PROPOSED GC0101 - LEGAL DRAFTING

GLOSSARY AND DEFINITIONS

Figure X6

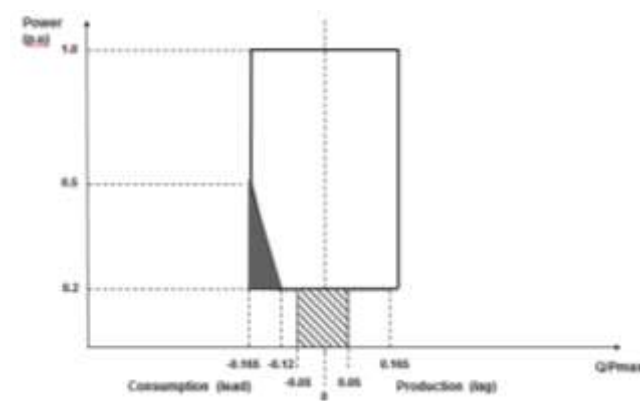
Comment [A7]: This requires further assessment and discussion - we also need to discuss if the need to mandate unity power factor control as a minimum is required

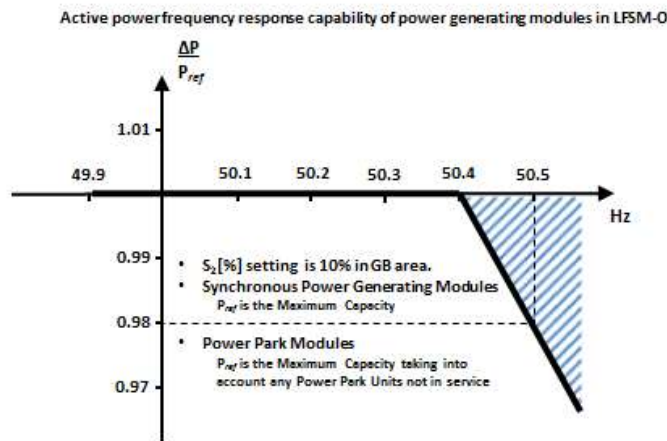
Comment [A18]: Update or duplicate diagram to include DC Converters, DC Connected Power Park Modules and Remote End DC Converters

Comment [A19]: . Note Synchronous Plant is treated differently from Asynchronous Plant. We would not want this characterisitc as we would expect all plant to behave in the same way irrespective of its type - ie deload by 2% of output irrespective of its loading level. The diagram will be updated to include this.

Figure X2 –Limited Frequency Sensitive Mode – Underfrequency capability of Power Generating Modules (including DC Connected Power Park Modules and HVDC Systems Equipment).

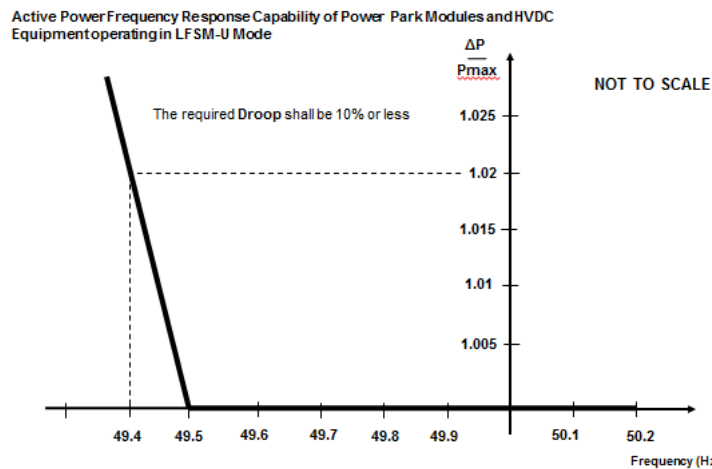
Comment [A22]: This diagram will need to be updated in respect of DC Converters

Comment [A23]: Diagram updated to reflect GB interpretation. Droop set at 10% on maximum capacity which is the same for Power Park Modules and Synchronous Power Generating Modules - note this is capability on full output not based on loading level Will need to be raised as part of Stakeholder consultation

Figure X3 Frequency Sensitive Mode capability of Power Generating Modules and DC Connected Power Park Modules

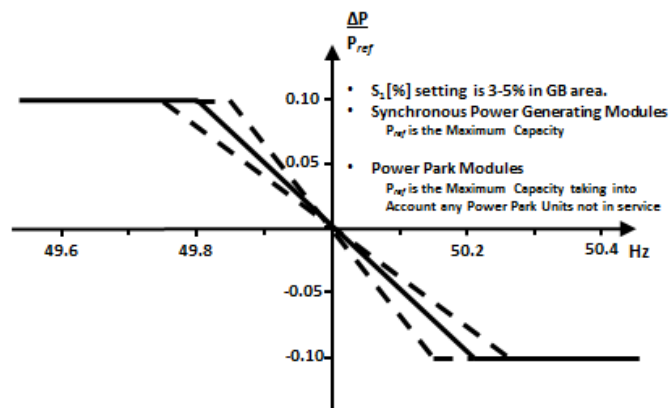
Comment [A24]: Diagram to be changed to remove the difference between Synchronous and Power Park Modules. - Capability is based on Maximum Capacity - further discussion required with Generator Compliance

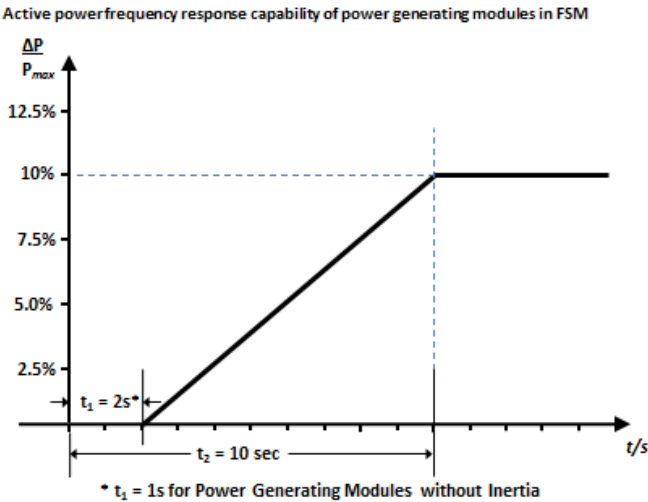
Comment [A25]: This could be simplified with just the parameters inserted and references to t_1 and t_2 removed.

Figure ECC.A.7.2.2b

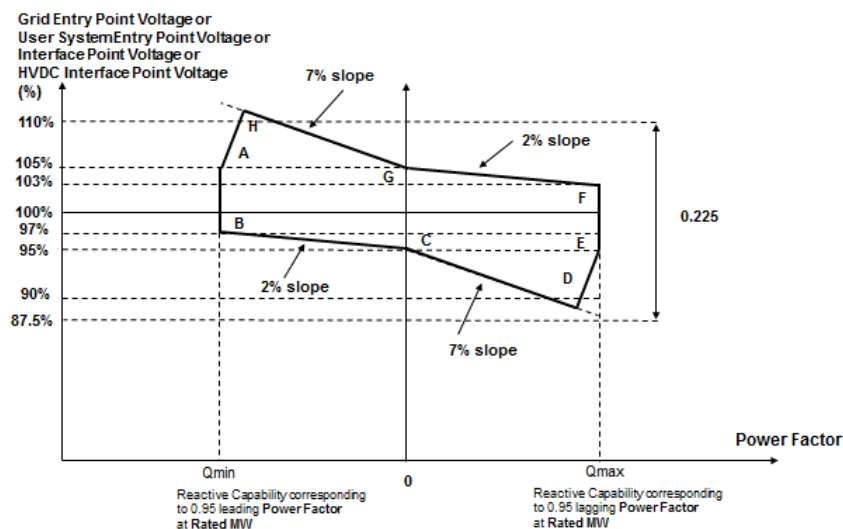
Comment [A41]: This diagram needs updating to include HVDC Interface Point Voltage
